Brookhaven National Laboratory
Plant Engineering - E&CS Division
Engineering Change Notice Form

PROJECT: CCWF II **JOB No.** 11705

ECN Title: Trane Chiller Remote Starter **ECN No.** 56A

JOB TITLE	DWG. TITLE
CHILLED COOLING WATER FACILITY EXPANSION–II	CHILLER 5 REMOTE STARTER CIRCUIT WIRING DIAGRAM

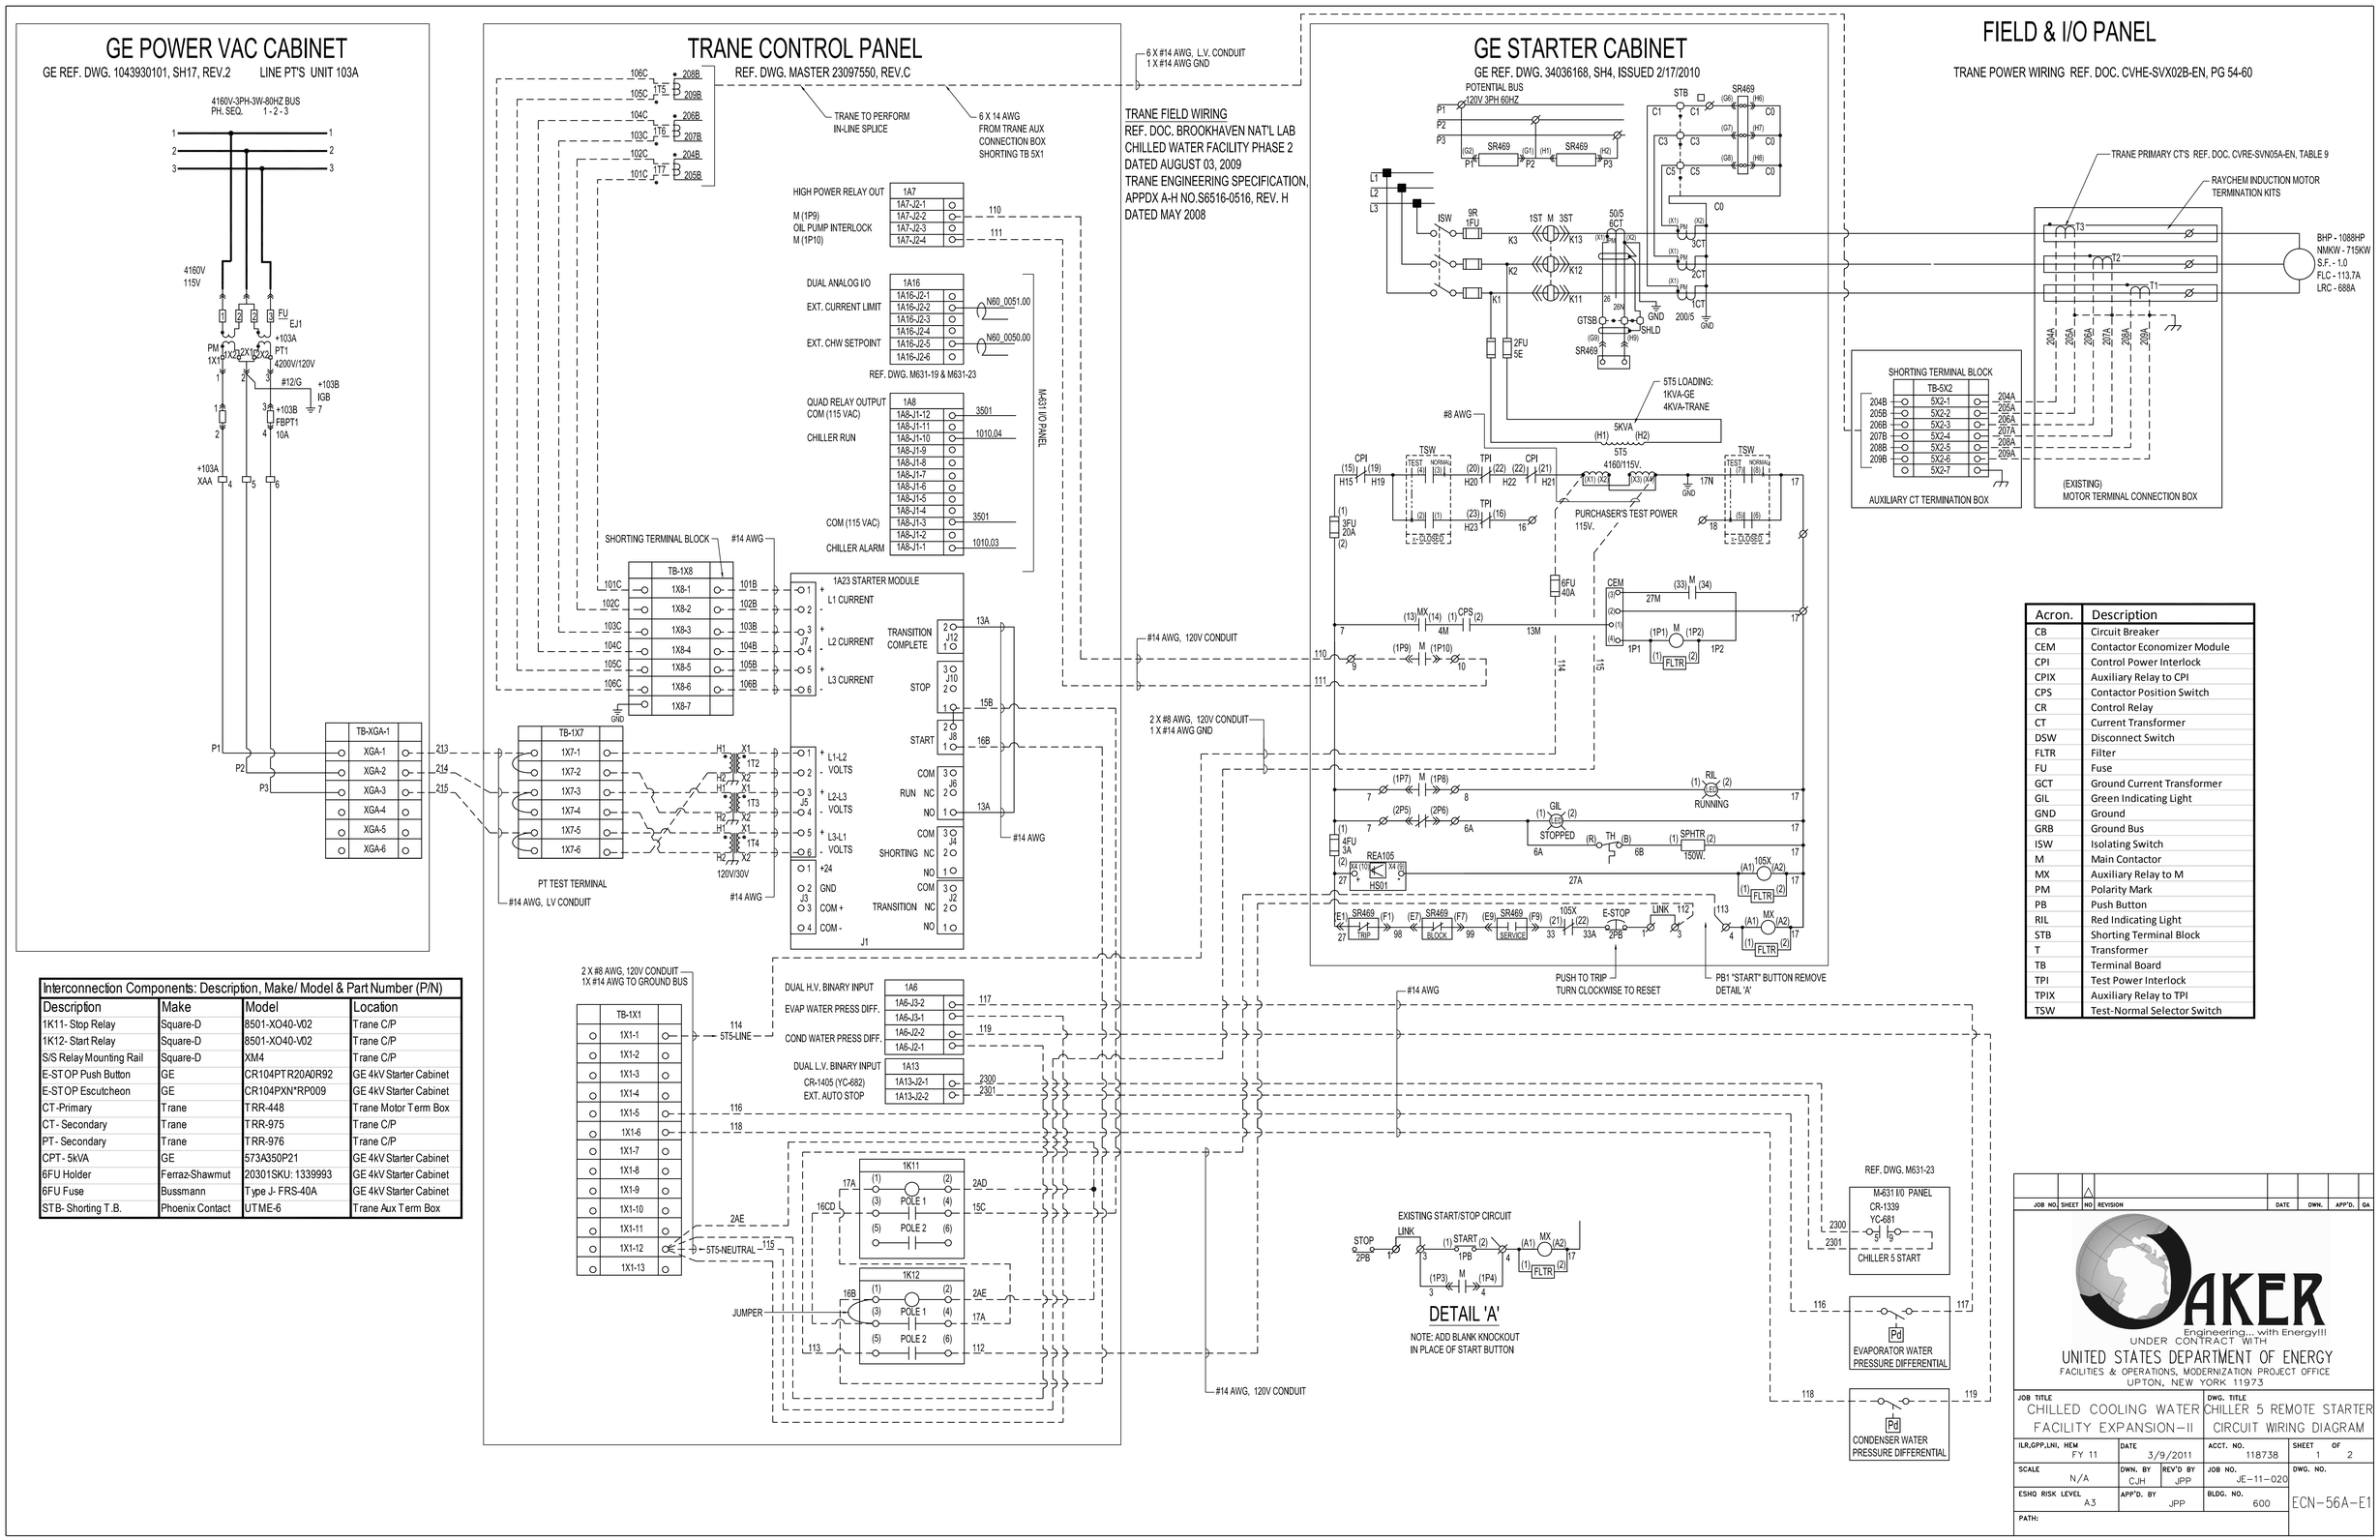
Requested Change (Attach sketch if applicable): Clarify interconnection requirements for Chillers 600CHL-5, 600CHL-6 remote starters based on Trane shop drawing submittals.

Resolution: Refer to attached Circuit Wiring Diagrams ECN-56-E1 (Chiller 5) and ECN-56-2 (Chiller 6).
